Appendix C
Future Build Conditions
LOS Analysis Worksheets

RESPONSE TO APRIL 11, 2011 SHA COMMENTS ON TRAFFIC IMPACT STUDY DATED MARCH 1, 2011

**RESPONSE TO MAY 24, 2011 SHA COMMENTS ON
THE DRAFT RESPONSE LETTER DATED APRIL 13, 2011**

This is a response to the SHA review comments provided on May 24, 2011 regarding the Traffic Study for the Post-Construction Phase of the proposed expansion at the Calvert Cliffs site in Lusby, MD prepared by KLD in cooperation with URS for UniStar. These responses also reflect input from follow up discussions with SHA. The comments are addressed below one by one, following each section of the review comments.

Temporal Distribution of CC3 Employees

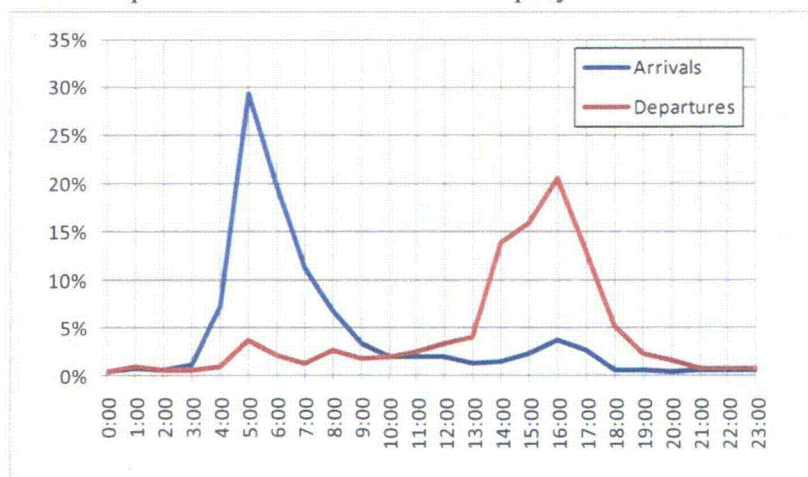
- 2) The SHA reiterates our concern with the trip generation. The Consultant indicates that the hourly distribution of the new work trips was based on the temporal curve for existing employee arrivals. If the total number of employees for the two existing reactors is 833, and the Temporal Distribution of Power Plant Employees graph shows approximately 290 inbound employees in the morning peak and 205 outbound in the evening peak, the percent of inbound employees during the morning peak hour would be approximately 34% and outbound would be approximately 25%. Based on the percentages, the new morning inbound trips would be 247 and the new outbound evening trips would be 182. However, the study trips are significantly less. The derivation of the peak hour trips must be updated.

Response: To address SHA's concerns, the maximum hourly volume of additional CC3 traffic will be added to the background peak hour traffic. The highest hourly percentages of total employee traffic based on the temporal curve is as follows:

The curve presenting the ATR counts will be updated to reflect % by time of day to clarify that the number of trips measured from the ATR does not correspond exactly to the 833 employees, due to the variability in daily trips. A new graph which reduces the raw data to percentages, similar to the one shown below, will replace the old figure.

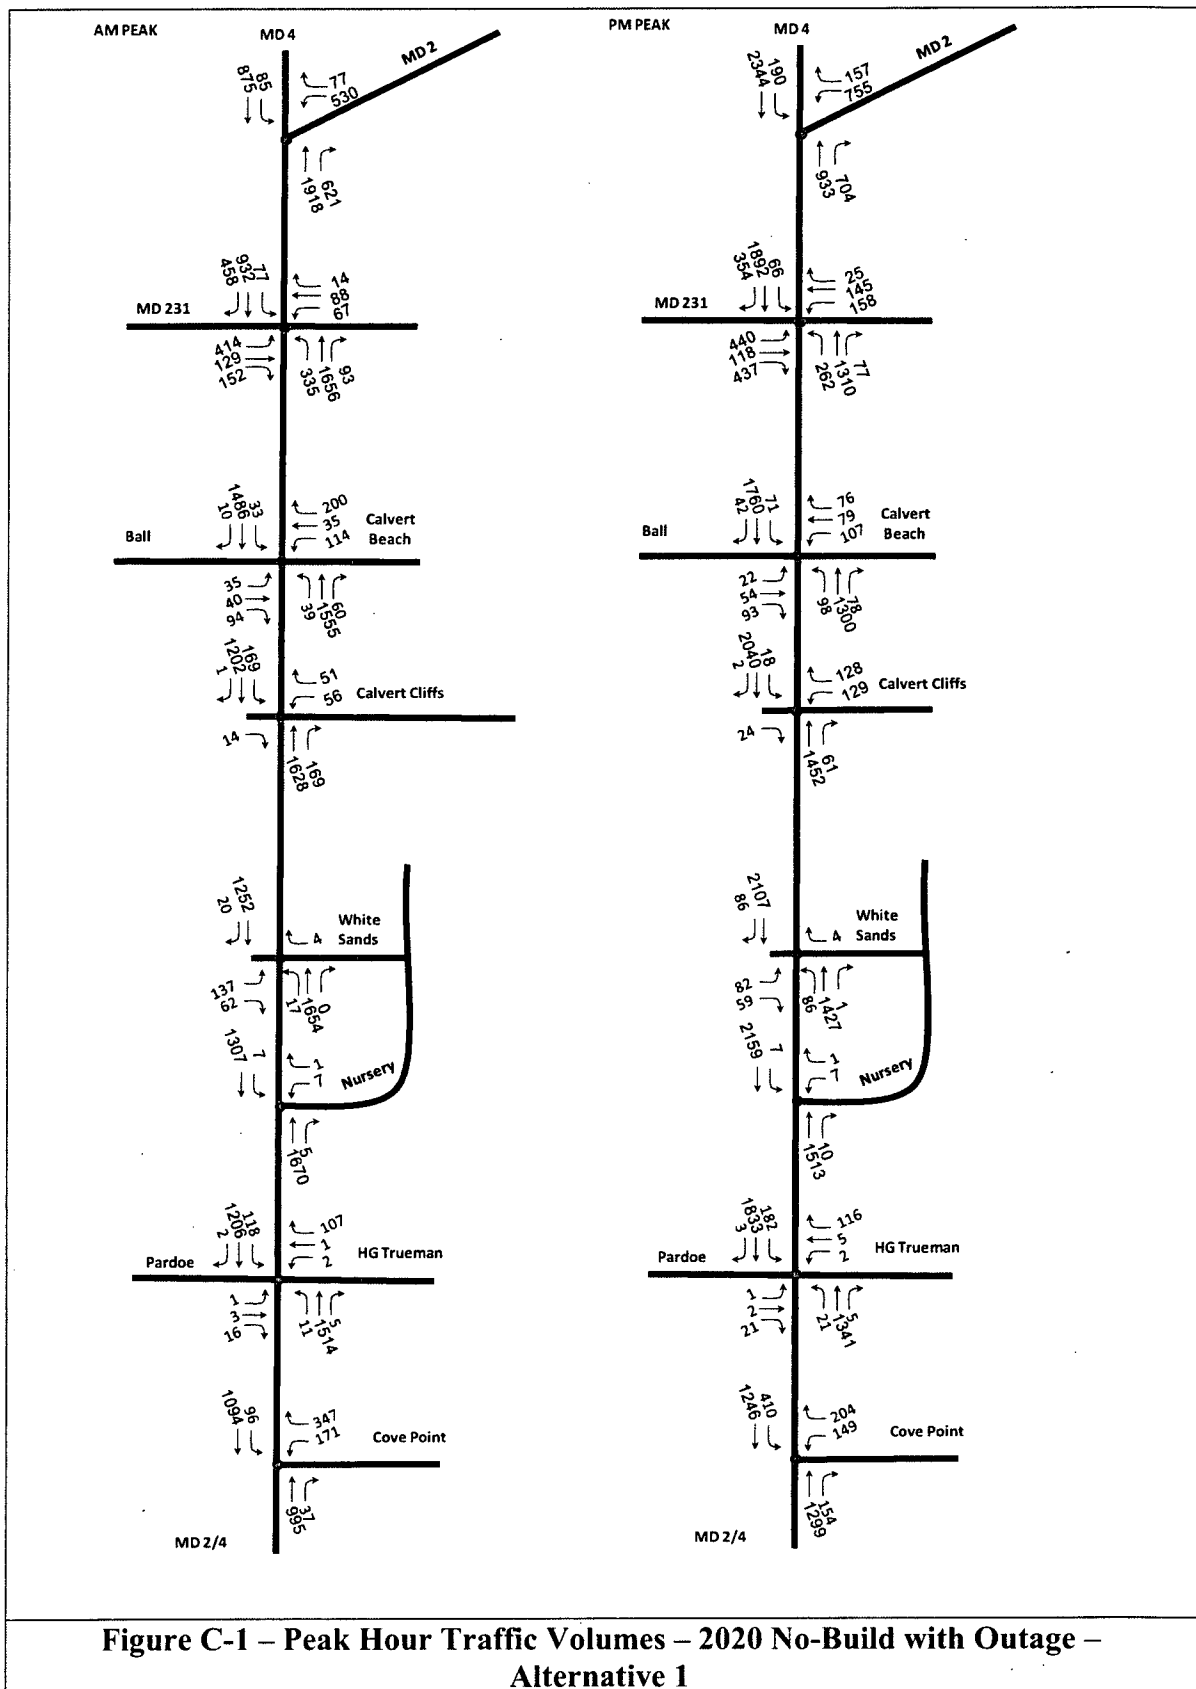
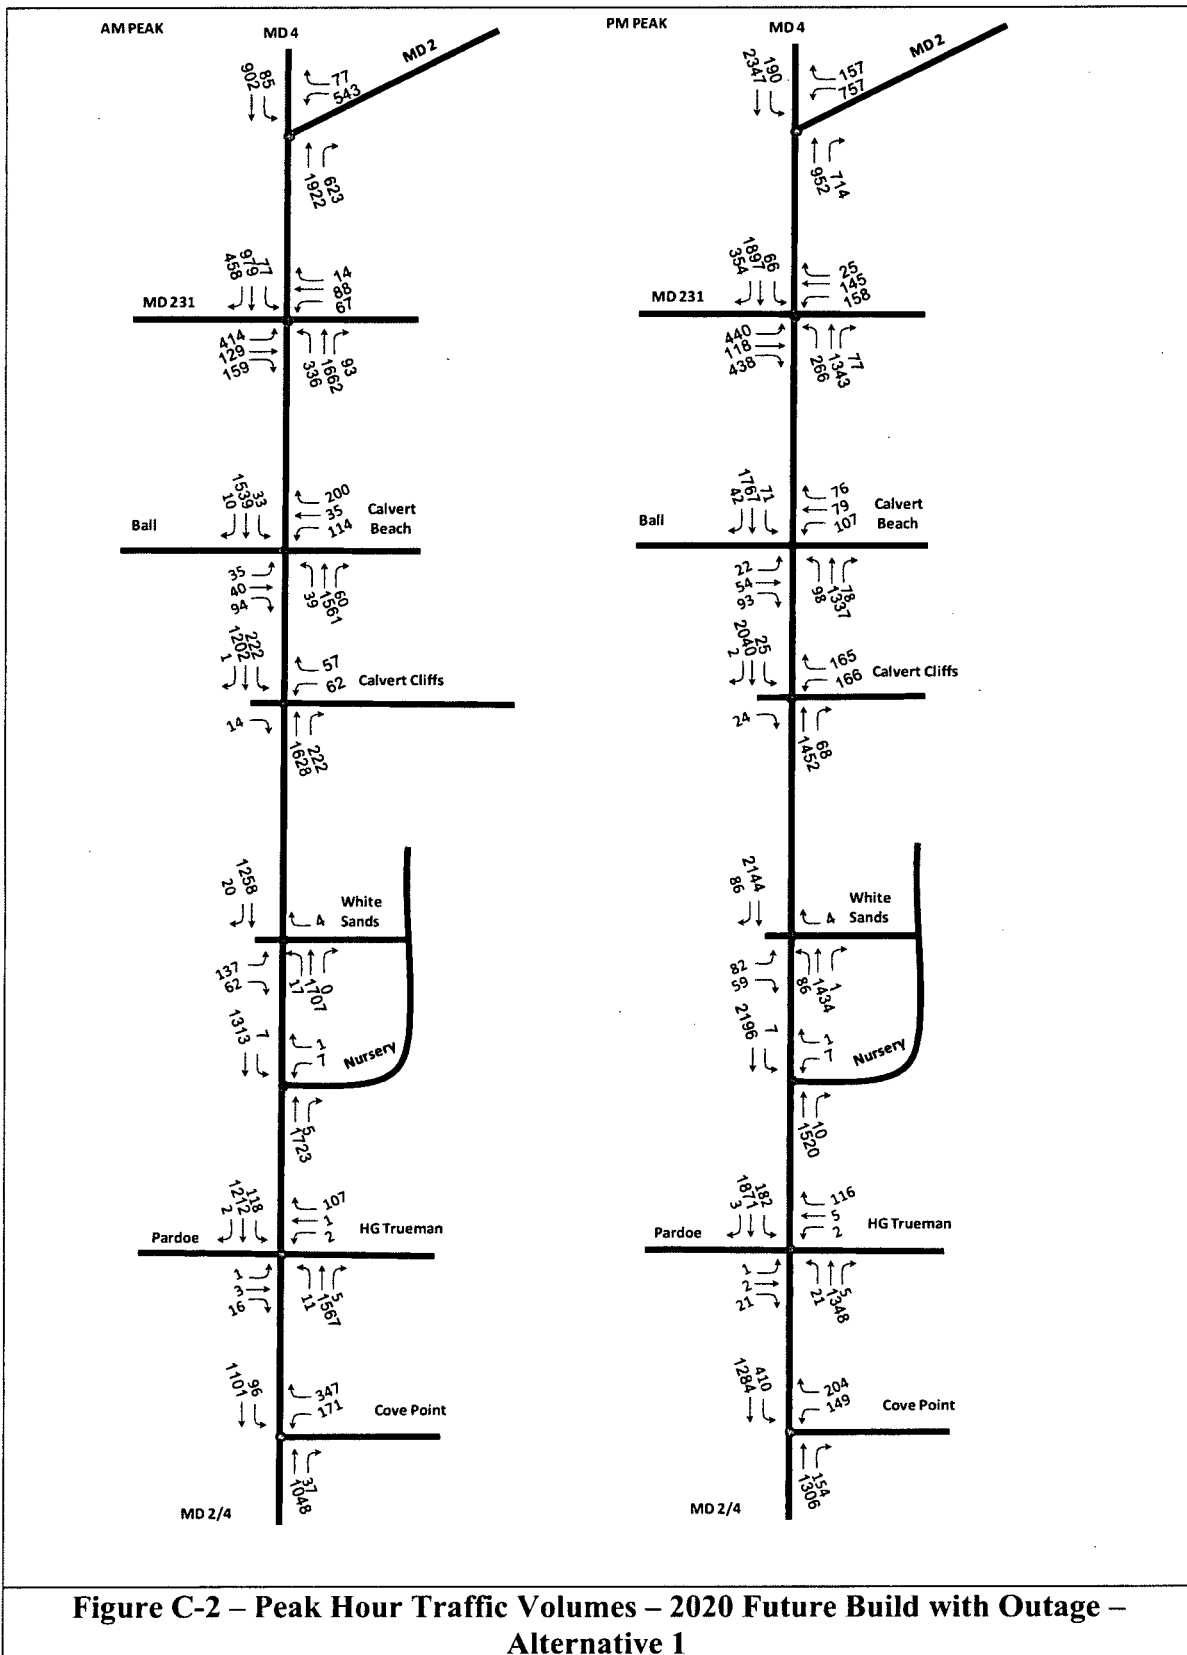
- 3) The preferred site access alternative for CC3 would be Alternative 1 – all access from Calvert Cliffs Parkway. The SHA will not approve an alternate access at this time.

Response: The SHA has stated that the preferred site access alternative would be the usage of Calvert Cliffs Parkway. The site ownership complications involved in committing to all traffic using Calvert Cliffs Parkway following construction has been discussed with the SHA and it was agreed that SHA would consider allowing alternative post construction access points if the Calvert Cliffs Parkway option is not viable due to factors beyond UniStar's control.
